**From:** Rhgilkeson@aol.com  
**Sent:** Friday, September 04, 2009 7:06 AM  
**To:** Kieling, John, NMENV  
**Cc:** Rhgilkeson@aol.com; ABERLYLAW@SWCP.COM; acree.steven@epa.gov; dave@radfreenm.org; jarends@nuclearactive.org; jd@campy.com; mayer.richard@epa.gov; mariann2@windstream.net; msantistevan@doeal.gov; serit@cybermesa.com; wilkin.rick@epa.gov  
**Subject:** Submittal of EPA Kerr Lab Reports to the NMED Public Comment Record  
**Attachments:** Kerr Lab Memo Feb 16, 2006.pdf; Kerr Lab Memo March 30, 2009,.pdf; Kerr Lab Memo, Feb 10, 2006.pdf

This e-mail brings to the attention of the New Mexico Environment Department (NMED) the three reports by the Environmental Protection Agency (EPA) Kerr Research Laboratory (EPA Kerr Lab) that describe the deficiencies in the various versions of two LANL reports that were approved by the New Mexico Environment Department.

*LANL Well Screen Analysis Report - Revision 2 (LA-UR-07-2852 May 2007)*

*LANL Groundwater Background Investigation Report - Revision 3 (LA-UR-07-2853 May 2007)*

**Figure 8.** The close locations of regional aquifer monitoring wells R-35a and R-35b to Los Alamos County drinking water supply well PM-3.

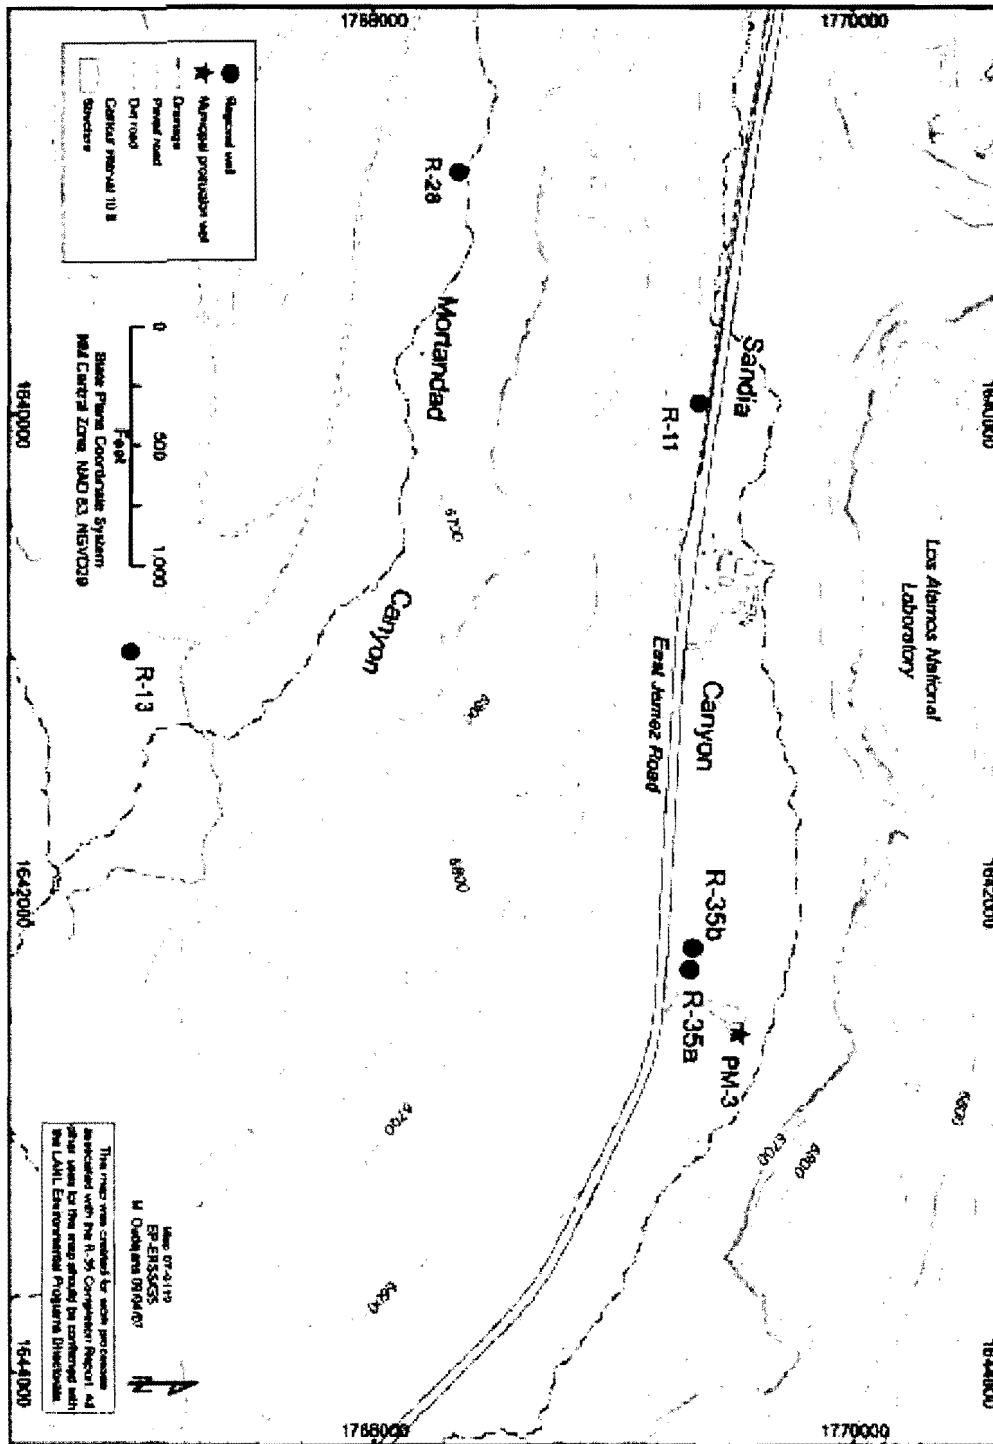
The dominant control of the mineralogy of the rock formation in the sampling zone of the LANL monitoring wells on the natural background chemistry of groundwater is illustrated by the large differences in background water quality in the groundwater produced from the LANL monitoring wells R-35a and R-35b and the drinking water well PM-3. The close locations of the three wells are shown on Figure 8.

- The close locations of wells R-35b, R-35a and PM-3 are displayed on Figure 8.

**Figure 9.** Conceptual schematic illustrating differential transport behavior of contaminants within the impacted zone adjacent to a well screen influenced by biodegradation of organic-based drilling fluids.

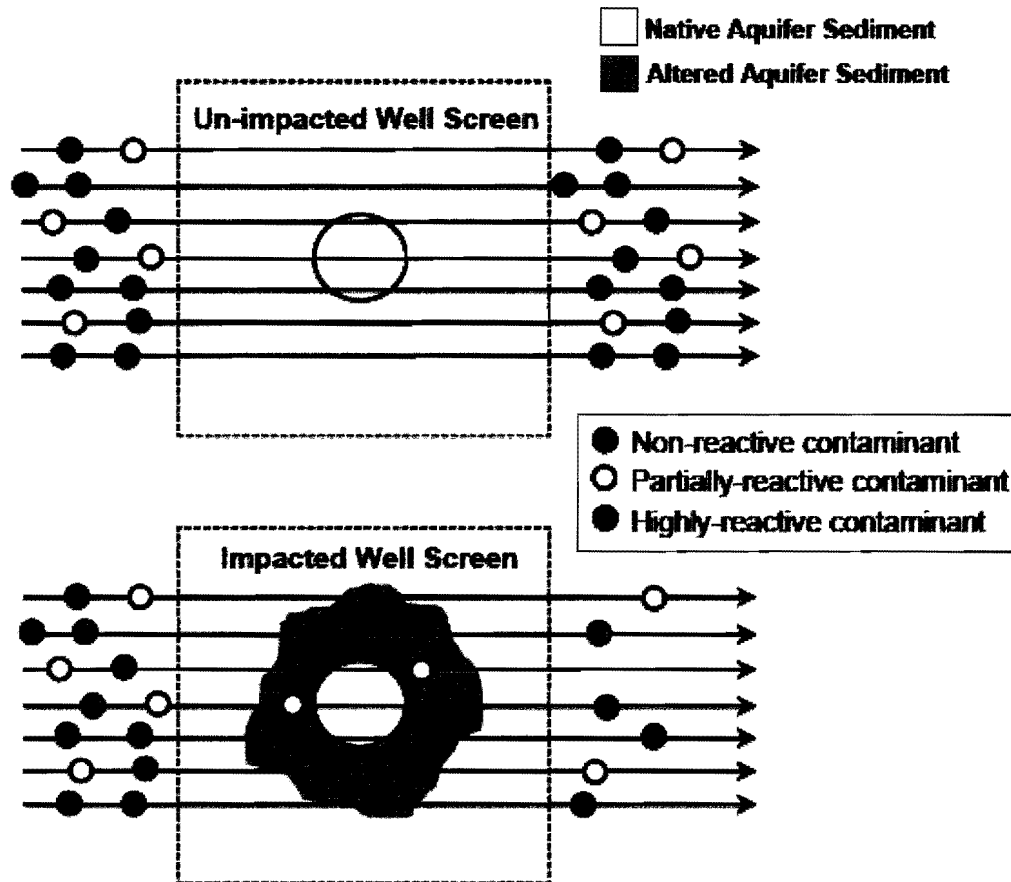
The organic drilling fluids have caused a new reactive chemistry in the zone where groundwater is produced from the LANL monitoring wells R-1, R-13 and R-21. The zone of reactive chemistry is displayed in Figure 9. The new chemistry prevents the wells from producing reliable and representative water samples for the background concentrations of the naturally occurring metals.

Figure 1. Location of monitoring well R-38 approximately 1500 feet northeast of LANL waste disposal site MDA L

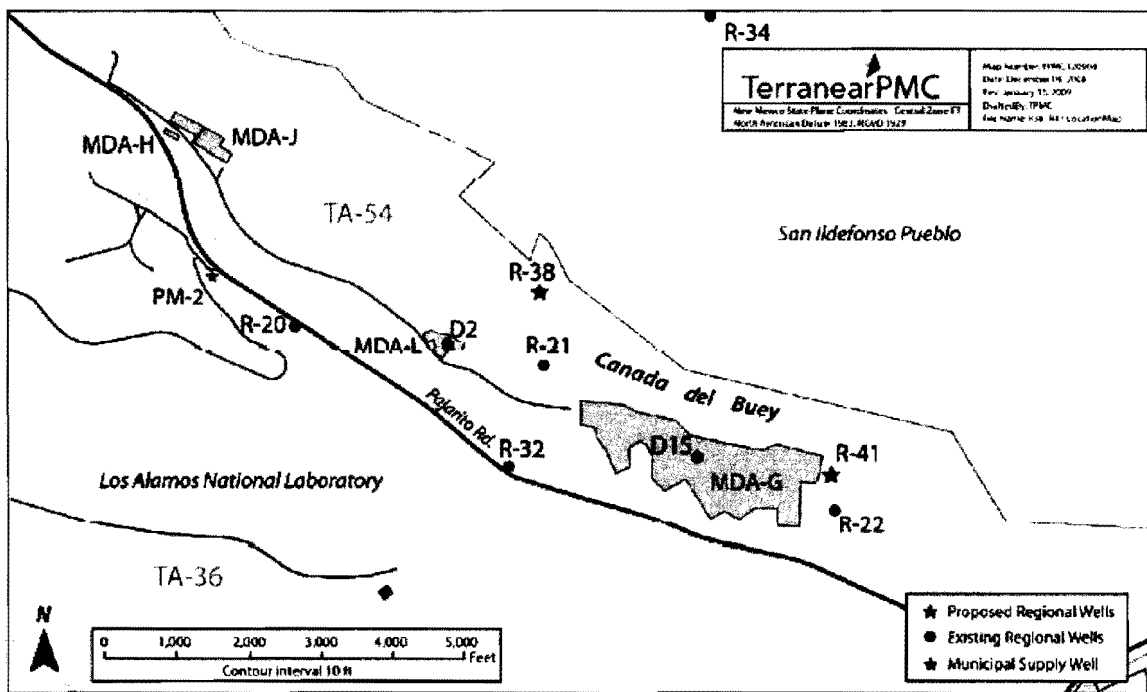
LANL monitoring well R-38 is located in the north fork of Canada del Buey to monitor contamination from MDA L. The location of well R-38 is displayed on Figure 1. Well R-38 is located approximately 1500 feet northeast of MDA L. Well R-38 was installed at the direction of the New Mexico Environment Department. The RACER database presents analytical data from two sampling dates for well R-38 which are February 6, 2009 and May 1, 2009. On both sampling dates, the three RCRA hazardous constituents Benzene, Toluene and Bis(2-ethylhexyl)phthalate were detected in the water produced from well R-38. The Benzene contamination measured in the water sample collected on February 6, 2009 was at a level greater than the EPA Drinking Water Standard (DWS) of 5 ug/L. Table 1 presents the water quality data for well R-38.

Figure 2. The large plumes of high-explosives contaminated groundwater assumed to be present in the regional aquifer below Canon de Valle and Martin Spring Canyon in TA-16 at Los Alamos National Laboratory. The two plumes are shown in red on the western side of the map.

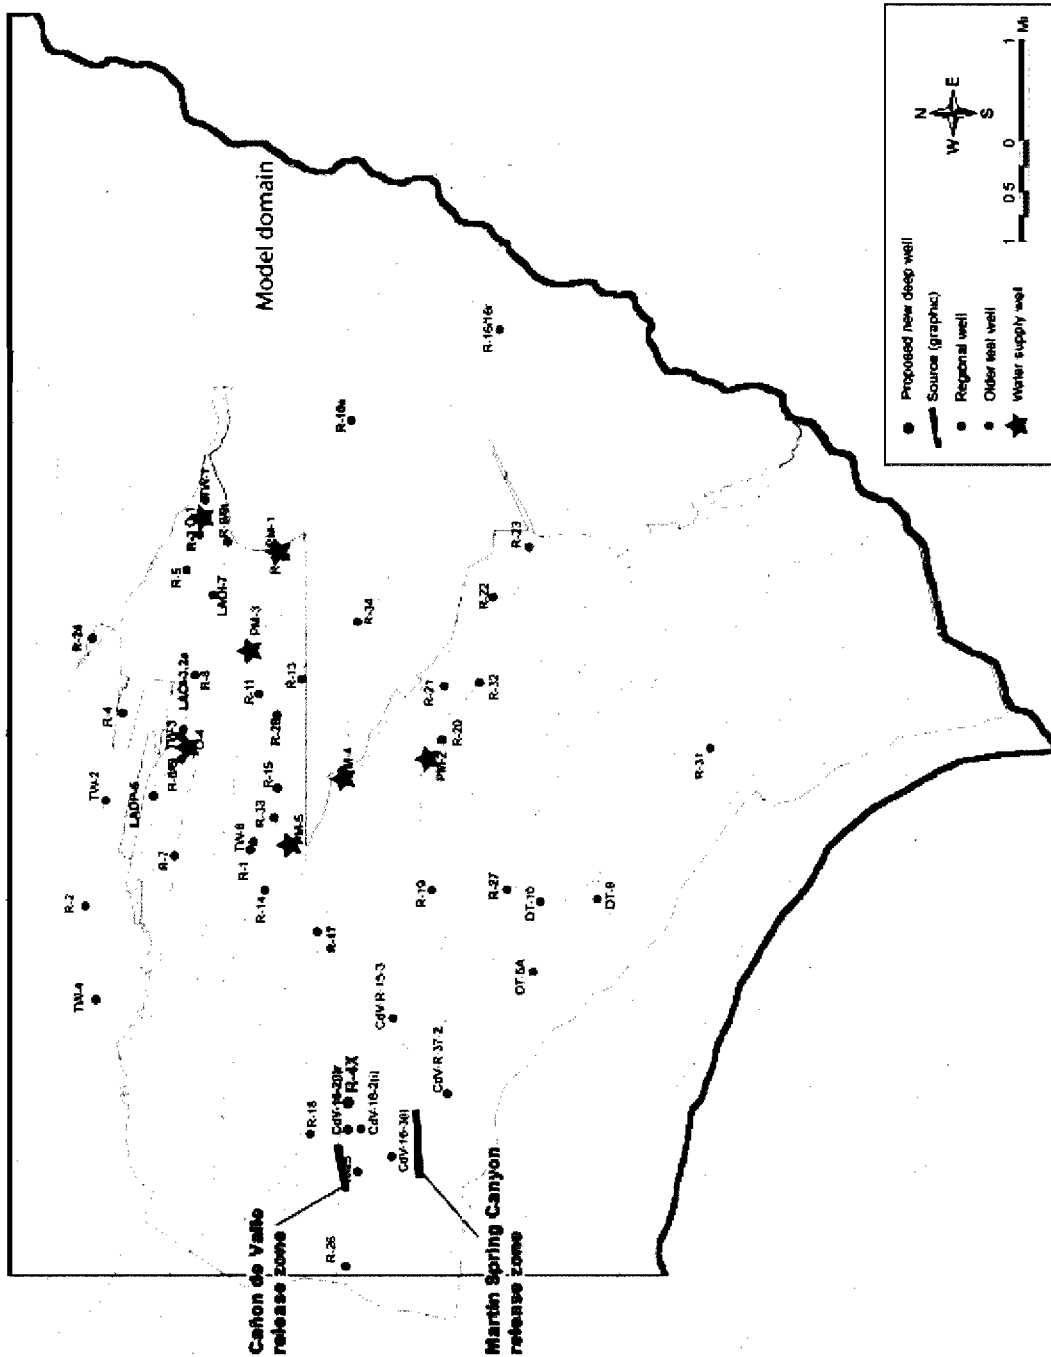
**All of the monitoring wells except well R-25 are located too far away from the contaminant release zones.** The time frame for detection of contamination at the TA-16 monitoring wells of 10 years is unacceptable. The strategy in the revised LANL report to allow great contamination of the regional aquifer over a distance of several miles is unacceptable by the New Mexico Water Quality Act. The network of monitoring wells is displayed on Figure 2. The revised plan installs only one new monitoring well in the regional aquifer. The new well is well R-4X on Figure 2. The proposed well R-4X is located one mile down gradient from the contaminant release zone in Cañon de Valle. The location of well R-4X is a mistake given the need to install monitoring wells close to the two release zones.

It is necessary for the NMED HWB to order LANL to install monitoring wells close to the contamination release zones at TA-16. Figure 2 shows that LANL multiple-screen monitoring well R-25 is the well that is located the closest to the Cañon de Valle release zone.

Figure 1. As-built design of LANL well R-22

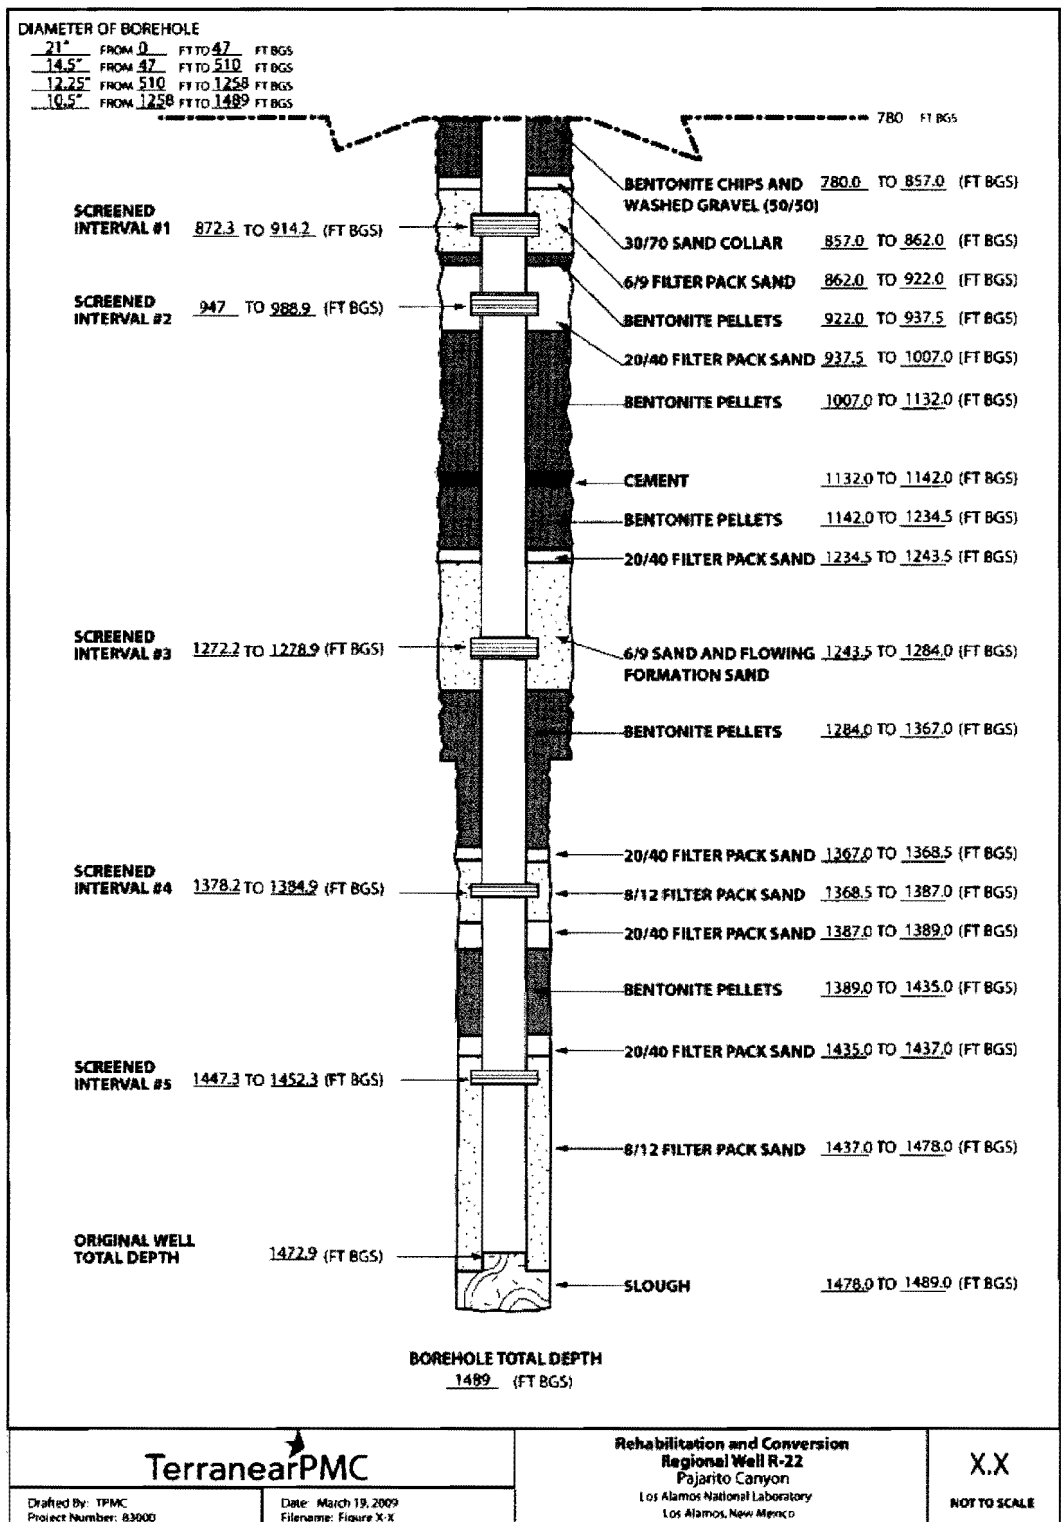
problems that prevent screen #3 from being used as a RCRA-compliant monitoring well are 1). the screen is installed in sediments with low permeability, 2). the mistake in the well construction that invaded the screened interval with bentonite clay grout and 3). the very long length of the filter pack sediments and "flowing formation sand" that surround screen #3 (see Figure 1).

Figure 2. The as-built construction of LANL characterization well R-22.

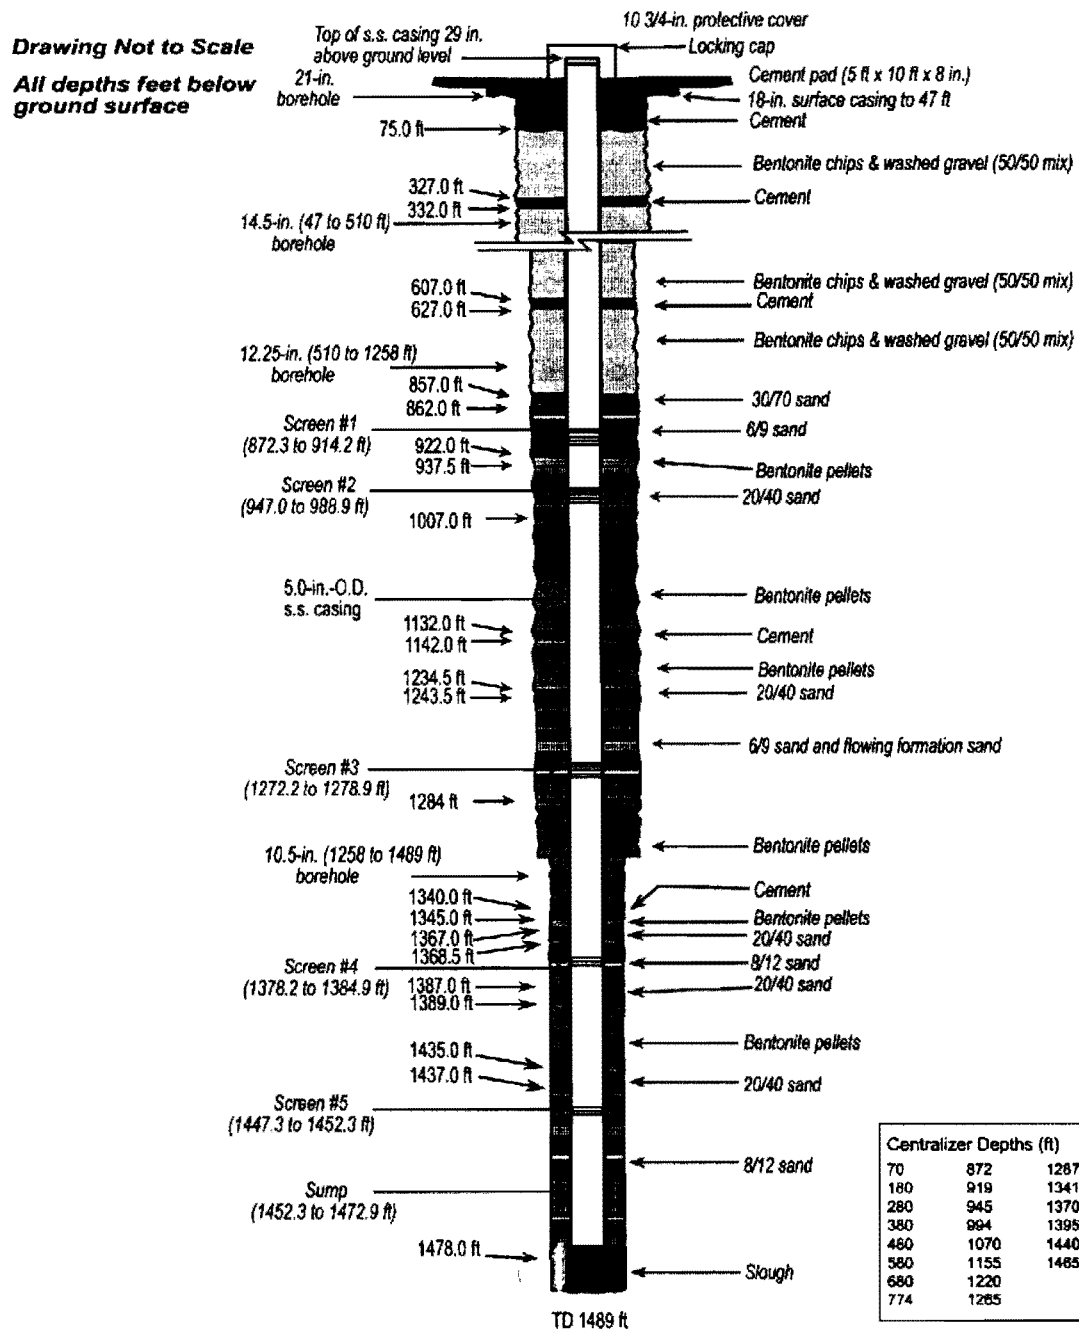
Figure 2 shows the as-built design of well R-22 with five well screens. Screen #1 is installed across the water table and screen #5 is installed at a depth of 560 feet below the water table. When the R-22 borehole was drilled in September of 2000, the top of the regional aquifer was at a depth of 883 feet below ground surface. The R-22 Plan will plug and abandon screens #4 and #5 and seal off screen #1. Jetting procedures will be used to redevelop screens #2 and #3. Then a pumping system will be installed in the well to produce water samples from screens #2 and #3. However, there are many factors that will prevent the rehabilitation of screens #2 and #3 from being successful. Those factors are described in the author's January 28, 2009 report and are summarized below. Well R-22 must be replaced because it does not meet the requirements of RCRA as a monitoring well but it is an important well for measurement of water levels.
